# **SERVICE INFORMATION NO. SI 20-044**

EASA Emergency Airworthiness Directive No 2011-0067-E

# REPLACEMENT OF WASHER PART NO. 944072 (FLY WHEEL HUB) FOR ROTAX<sub>®</sub> ENGINE TYPE 912 AND 914 (SERIES) SB-912-058 SB-914-041

Fig. 1 magneto ring, fly wheel hub, ignition cover

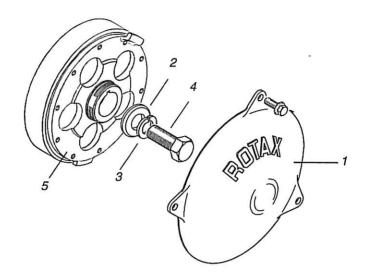
See fig. 1.

- 1. Remove ignition cover (1).
- 2. Lock the crankshaft in accordance with the relevant Maintenance Manual (Line).
- 3. Remove hex. screw (4) in accordance with the relevant Maintenance Manual (Heavy).

- ♦ NOTE: Fly wheel hub does not have to be removed unless it has become loose.
- CAUTION: If the fly wheel hub has loosened during the dissassembly and/or in case of doubt, then remove, clean and install the fly wheel hub in accordance with the relevant Maintenance Manual. In this case the tightening torque is 45 Nm (33.2 ft.lb) + 180° angle to rotation.

- 4. Install hex. screw (4). Tightening torque 120 Nm (89 ft.lb).
- CAUTION: During installation the new washer (2) part no. 944072 must be used.
- 5. Remove locking pin of crankshaft in accordance with the relevant Maintenance Manual.

- Check trigger coil gap, if necessary adjust it in accordance with the relevant Maintenance Manual.
- 7. Install ignition cover (1). The hex. screws (6) are locked with Loctite 221. Tightening torque 5 Nm (44 in. lb.).
